SERVICE BULLETIN

INSPECTION OF SLINGSBY T67 FIREFLY AIRCRAFT FOR FITTING OF UNDERCUT BOLTS

**Figure 11 - Rudder Bar on T67
From IPC T67, Chapter 19, Figure 7**

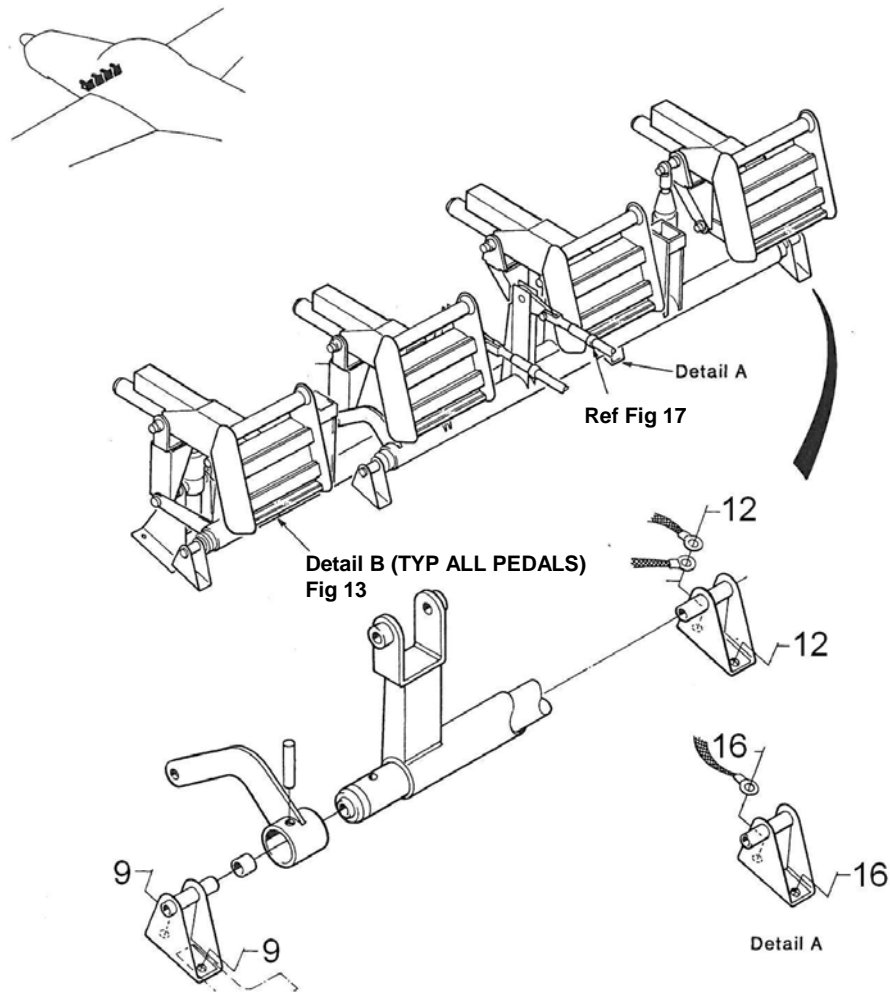
EXPLODED VIEW OF RUDDER BAR, INDICATING BOLTS WHICH REQUIRE INSPECTIONS AS PER SECTION 3, PARAGRAPH D, PART A, STEP 2. IF BOLT UNDERCUT IS IDENTIFIED, REPLACE WITH STANDARD BOLT AS INDICATED IN ABOVE TABLE.

**Figure 12 - Rudder Bar on T67M260
From IPC T67M260, Chapter 19, Figure 7**

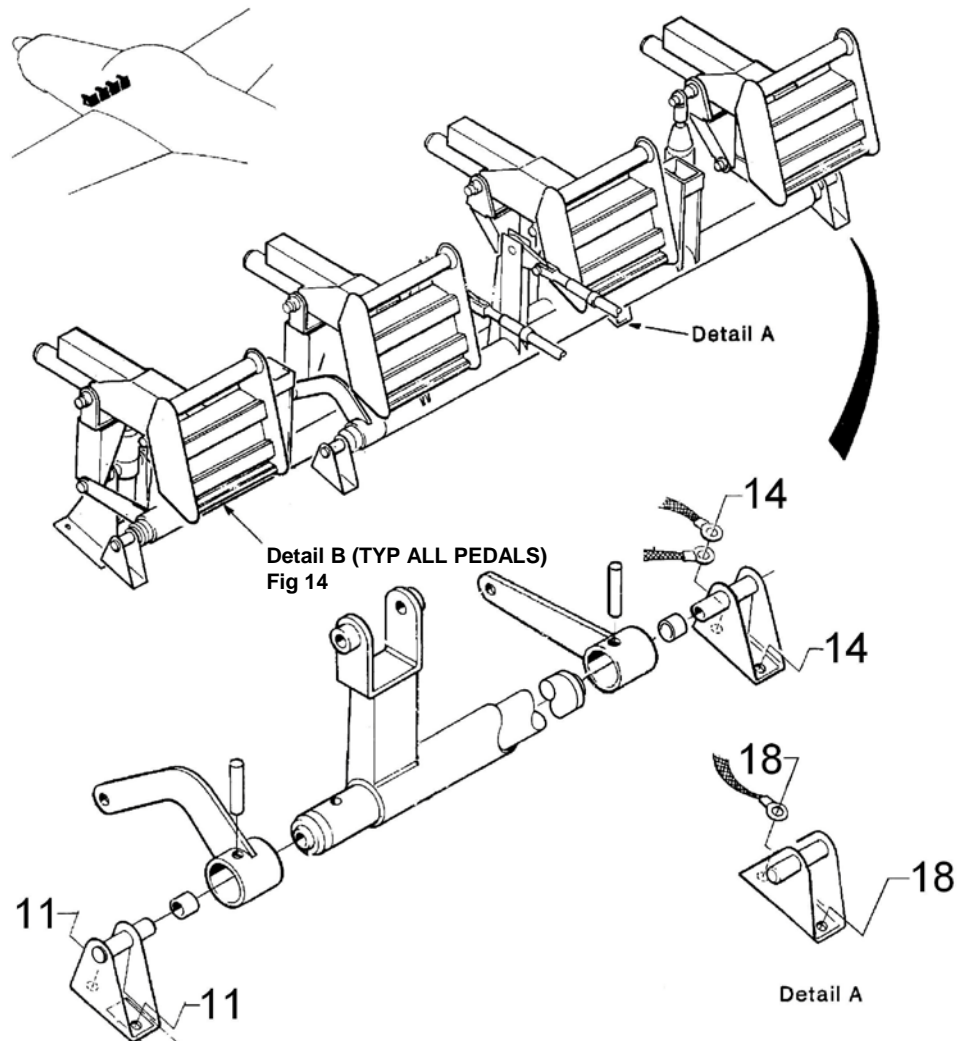
EXPLODED VIEW OF RUDDER BAR, INDICATING BOLTS WHICH REQUIRE INSPECTION AS PER SECTION 3, PARAGRAPH D, PART A, STEP 2. IF BOLT UNDERCUT IS IDENTIFIED, REPLACE WITH STANDARD BOLT AS INDICATED IN ABOVE TABLE.

**Figure 13 - Rudder Pedals on T67
From IPC T67, Chapter 19, Figure 8**

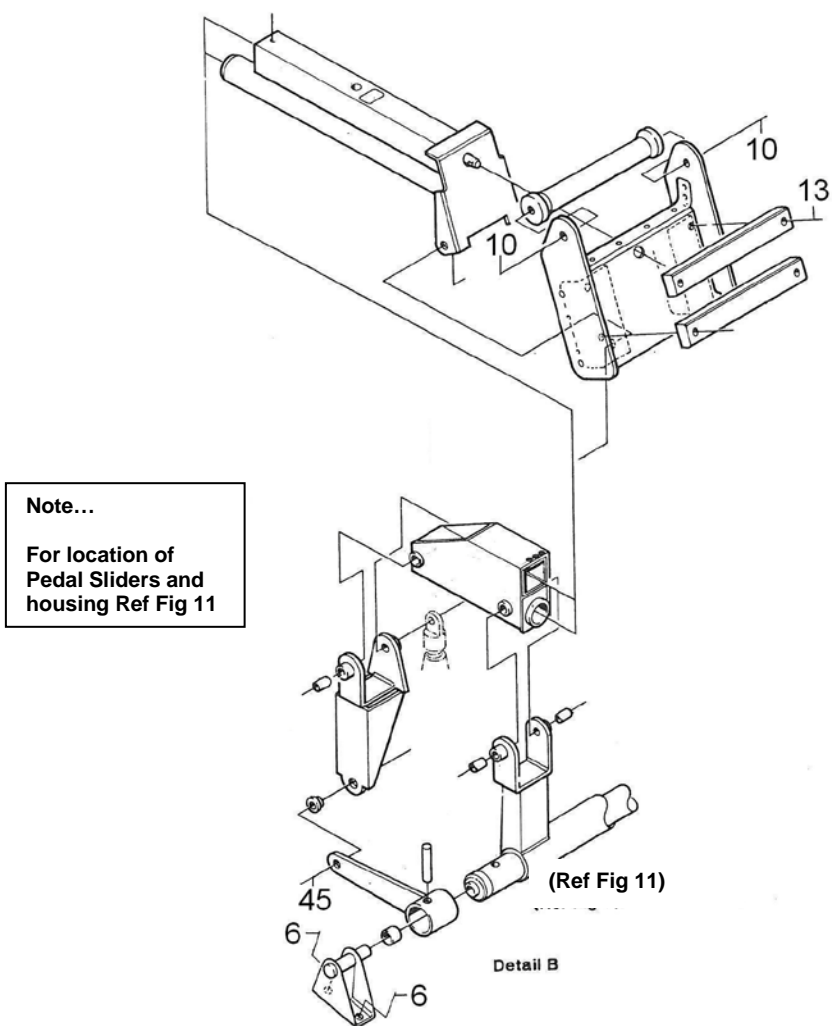
EXPLODED VIEW OF RUDDER BAR, INDICATING BOLTS WHICH REQUIRE INSPECTIONS AS PER SECTION 3, PARAGRAPH D, PART A, STEP 2 ON EACH PEDAL. IF BOLT UNDERCUT IS IDENTIFIED, REPLACE WITH STANDARD BOLT AS INDICATED IN ABOVE TABLE.

**Figure 14 - Rudder Pedals on T67M260
From IPC T67M260, Chapter 19, Figure 8**

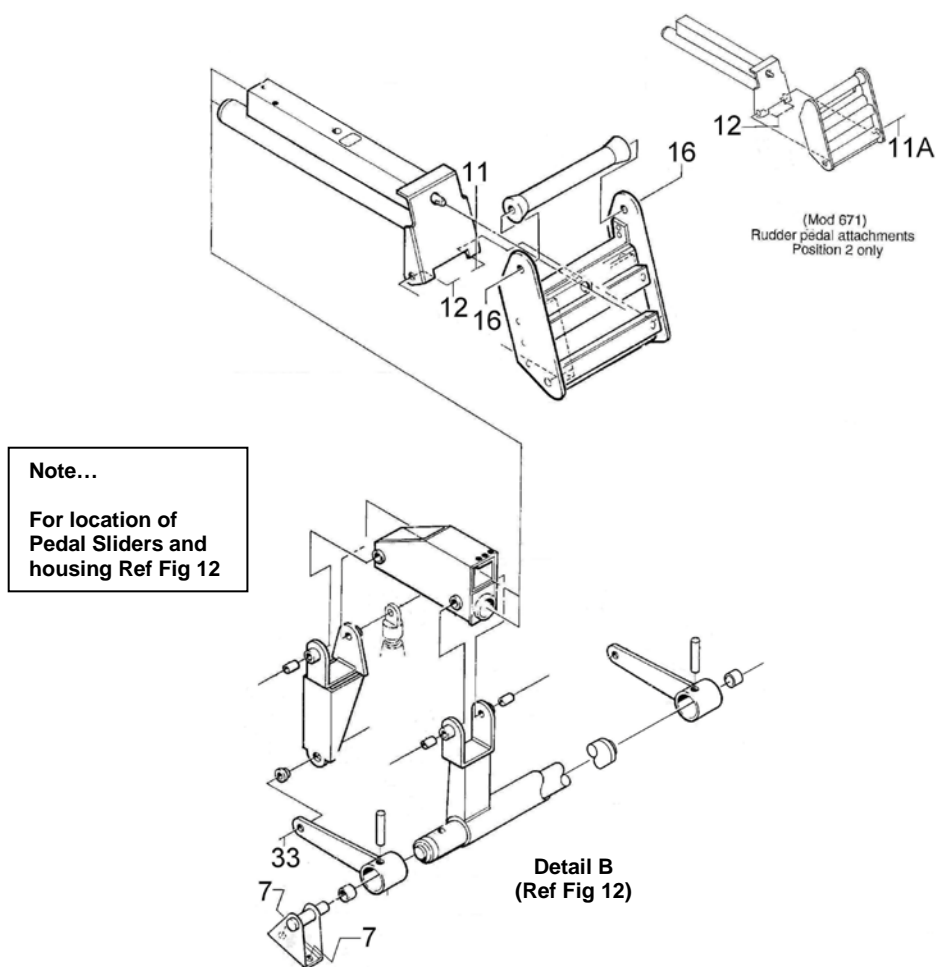
EXPLODED VIEW OF RUDDER PEDALS, INDICATING BOLTS WHICH REQUIRE INSPECTION AS PER SECTION 3, PARAGRAPH D, PART A, STEP 2 ON EACH PEDAL. IF BOLT UNDERCUT IS IDENTIFIED, REPLACE WITH STANDARD BOLT AS INDICATED IN ABOVE TABLE.

**Figure 15 – Master Cylinder on T67
From IPC T67, Chapter 21, Figure 3**

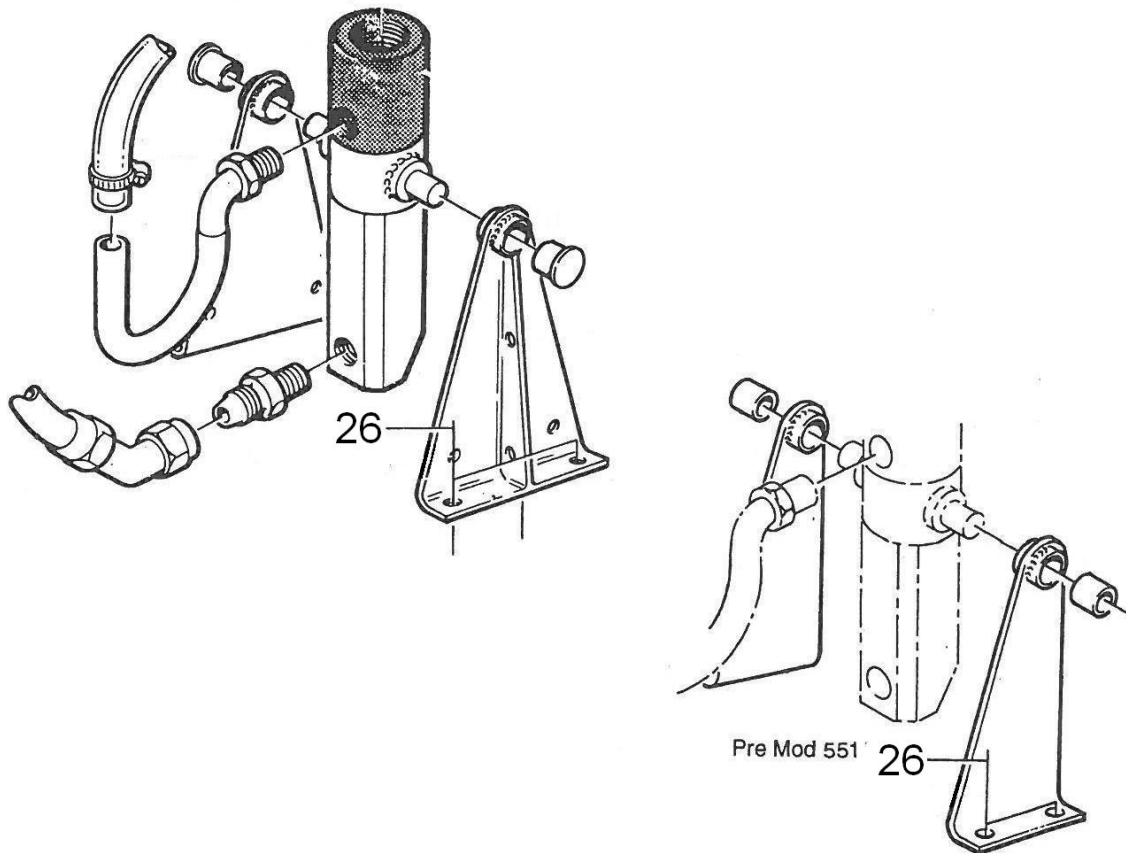
EXPLODED VIEW OF MASTER CYLINDER, INDICATING BOLTS WHICH REQUIRE INSPECTION AS PER SECTION 3, PARAGRAPH D, PART A, STEP 2 ON EACH RESEVOIR. IF BOLT UNDERCUT IS IDENTIFIED, REPLACE WITH STANDARD BOLT AS INDICATED IN ABOVE TABLE.

**Figure 16 – Master Cylinder on T67M260
From IPC T67M260, Chapter 21, Figure 3 AND 3A**

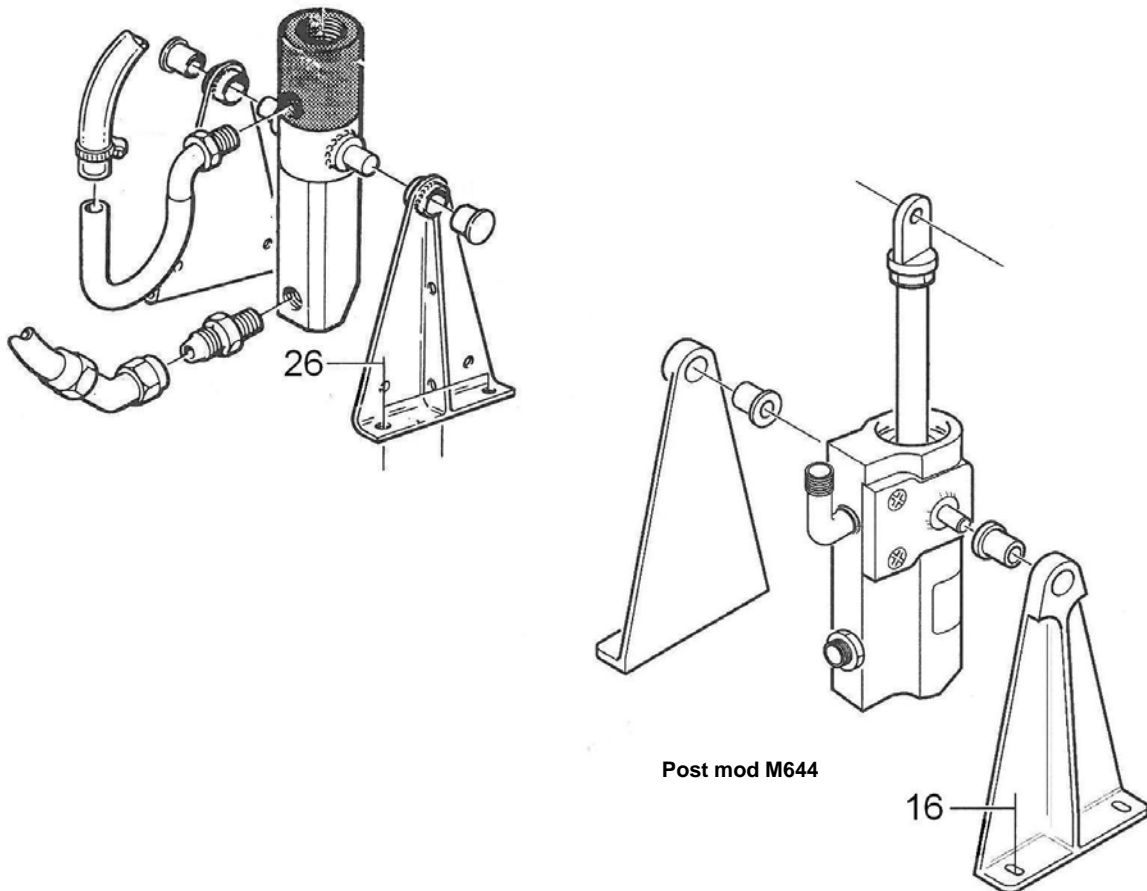
EXPLODED VIEW OF MASTER CYLINDER, INDICATING BOLTS WHICH REQUIRE INSPECTION AS PER SECTION 3, PARAGRAPH D, PART A, STEP 2 ON EACH RESEVOIR. IF BOLT UNDERCUT IS IDENTIFIED, REPLACE WITH STANDARD BOLT AS INDICATED IN ABOVE TABLE.

**Figure 17 - Rudder Cable Attachment on T67 & T67M260
From IPC T67 and T67M260, Chapter 19, Figure 9**

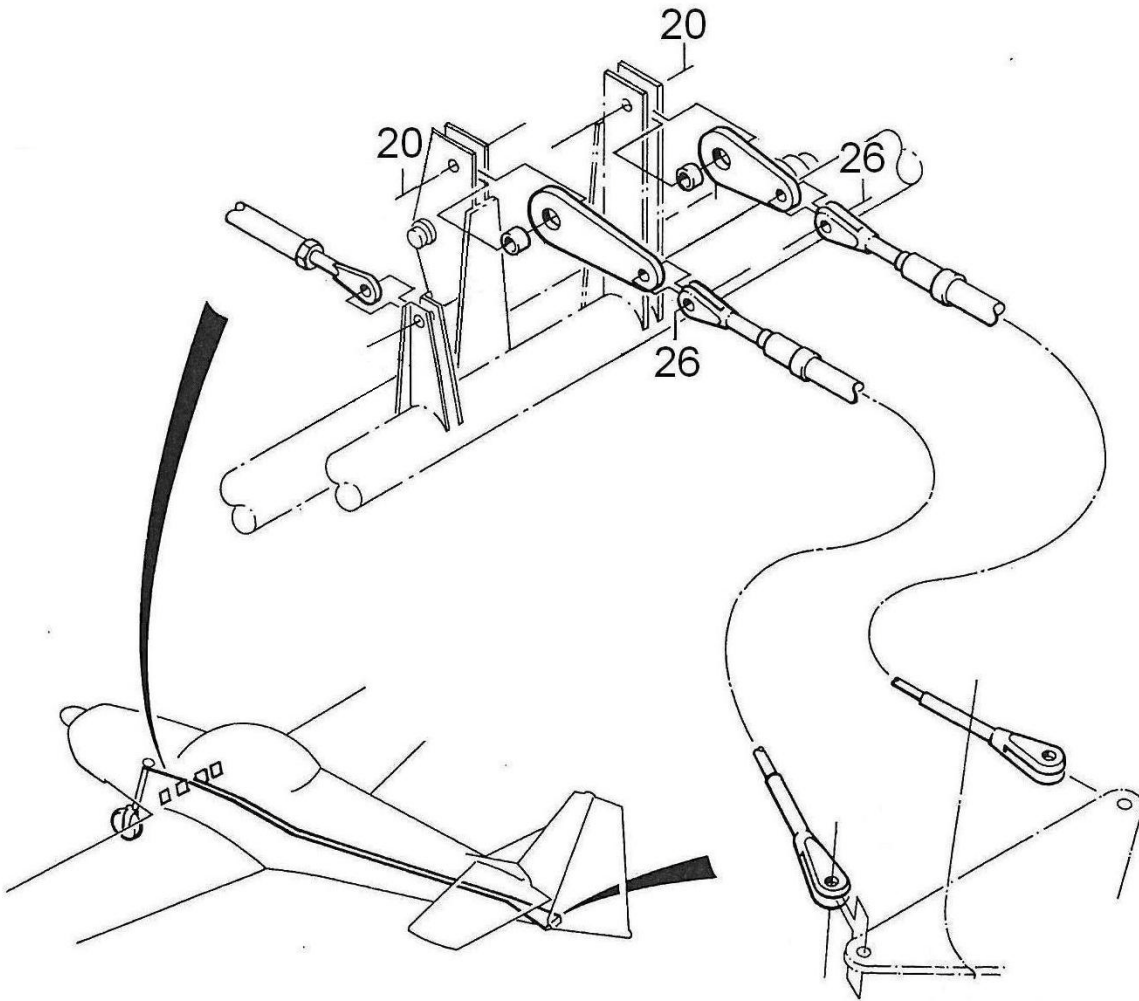
EXPLODED VIEW OF RUDDER PEDALS, INDICATING BOLTS WHICH REQUIRE INSPECTION AS PER SECTION 23, PARAGRAPH D, PART A, STEP 2. IF BOLT UNDERCUT IS IDENTIFIED, REPLACE WITH STANDARD BOLT AS INDICATED IN ABOVE TABLE.

Figure 18 - Rudder Cable Attachment on T67A and T67M Works N° 1999

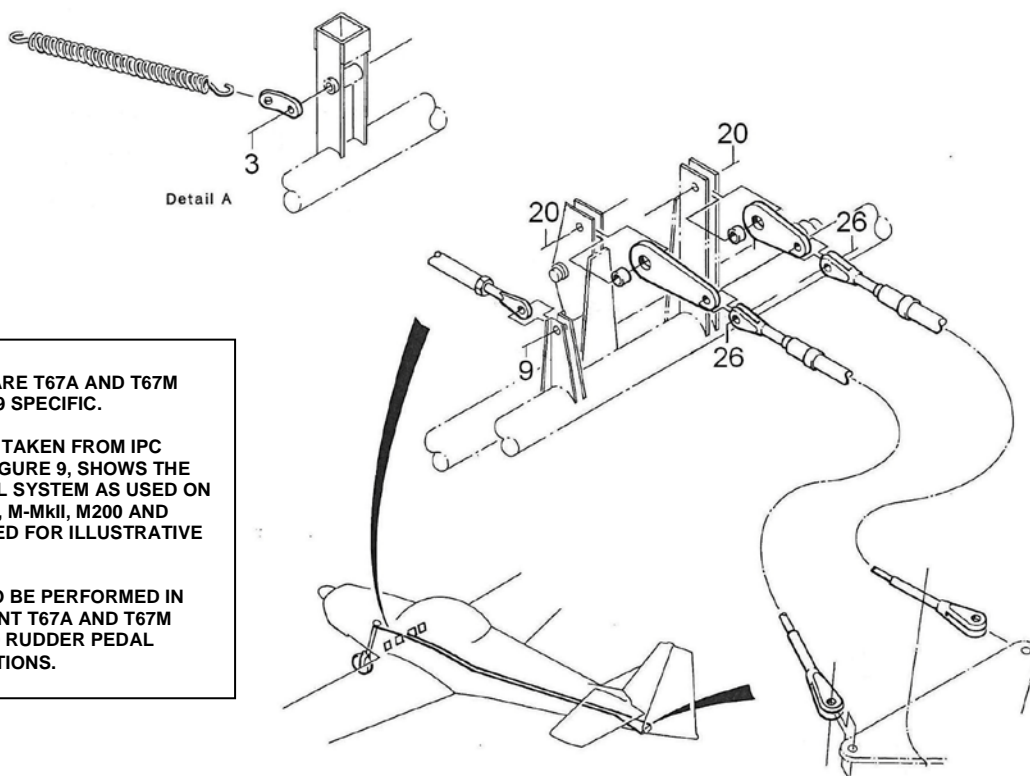
NOTE...
THESE ITEMS ARE T67A AND T67M WORKS N° 1999 SPECIFIC.

INSPECTION TO BE PERFORMED IN THE EQUIVALENT T67A AND T67M WORKS N°1999 RUDDER PEDAL SYSTEM LOCATIONS.

EXPLODED VIEW OF RUDDER PEDALS, INDICATING BOLTS WHICH REQUIRE INSPECTION AS PER SECTION 3, PARAGRAPH D, PART A, STEP 2. IF BOLT UNDERCUT IS IDENTIFIED, REPLACE WITH STANDARD BOLT AS INDICATED IN ABOVE TABLE.

Figure 19 - Rudder Pedals on T67A's and T67M Works N° 1999

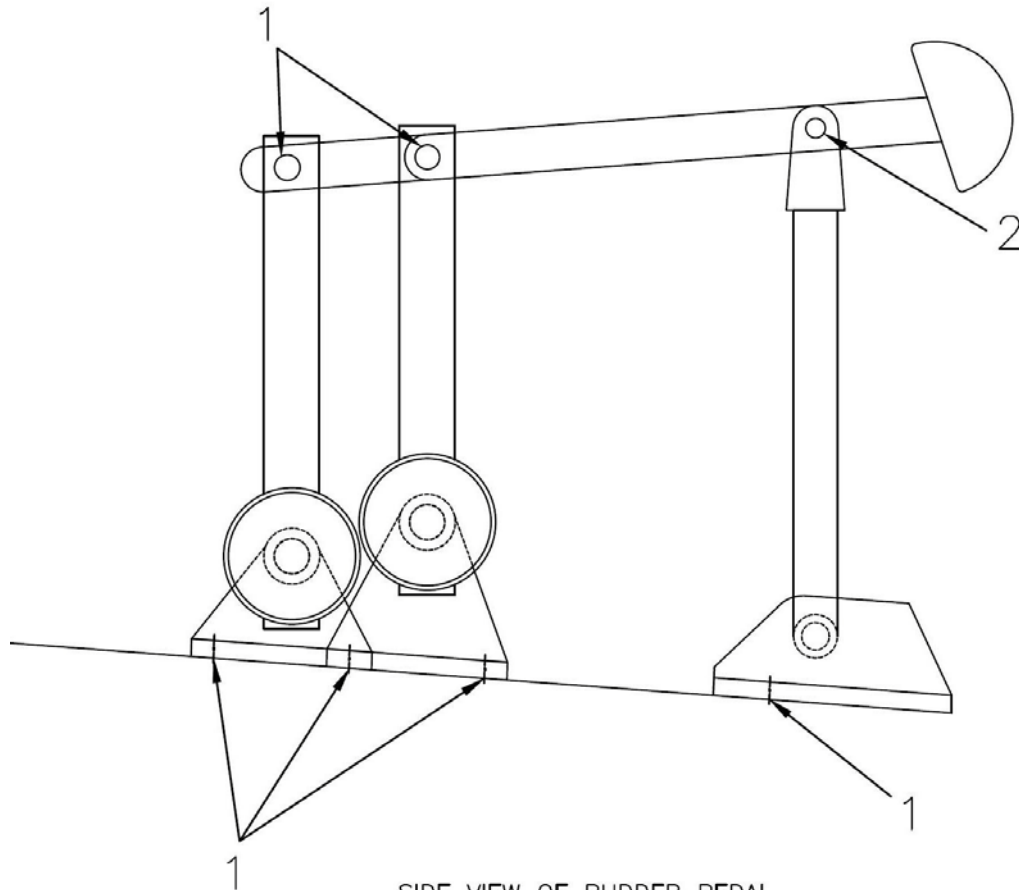
ARROWED ITEMS TO BE INSPECTED

SIDE VIEW OF RUDDER PEDALS, INDICATING BOLTS WHICH REQUIRE INSPECTION AS PER SECTION 3, PARAGRAPH D, PART A, STEP 2 ON EACH PEDAL. IF BOLT UNDERCUT IS IDENTIFIED, REPLACE WITH STANDARD BOLT AS INDICATED IN ABOVE TABLE.
